Service Bulletin

Bulletin No.: PIP6072

Subject: R1234YF Flush Error Message Information

6954821

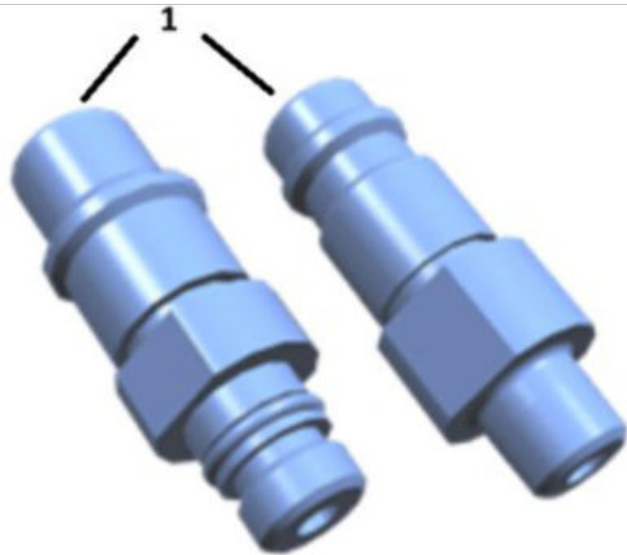
Involved Region or Country	North America
Condition	<p>While performing refrigerant flushing procedures, dealers may encounter an error message on their equipment indicating there is a possible clogged flushing filter or closed charge coupler valve when the filter is clear and the charge coupler valve is open.</p>  <p style="text-align: right;">6954820</p>
Cause	<p>A possible cause for this condition is that a restriction is detected by the equipment due to design changes between older flushing adapters (GE-45268-130) and new revisions of the adapters (GE-45268-130-A).</p> <p>When service equipment is connected to the GE-45268-130, and the knob on the back of the quick connect is tightened, the core depressor in the quick connect end blocks the passage of refrigerant through the adapter.</p>

The passage through the middle of the GE-45268-130-A adapter is the size of a 1/4 inch drill bit and the prior adapter GE-45268-130 has a smaller opening.

1 Above shows the portion of the adapter that should have a 1/4 inch opening

If dealers encounter this error message and determine that it is being caused by an incorrect adapter, they are encouraged to order the appropriate adapter through the Dealer Equipment and Special Tools portal in Global Connect whenever possible.

Our suppliers are working to remedy this situation by modifying their inventory of the GE-45268-130 adapter to meet GE-45268-130-A standards by enlarging the passage through the adapter or by acquiring the correct revision of the adapter to make them available for dealers.
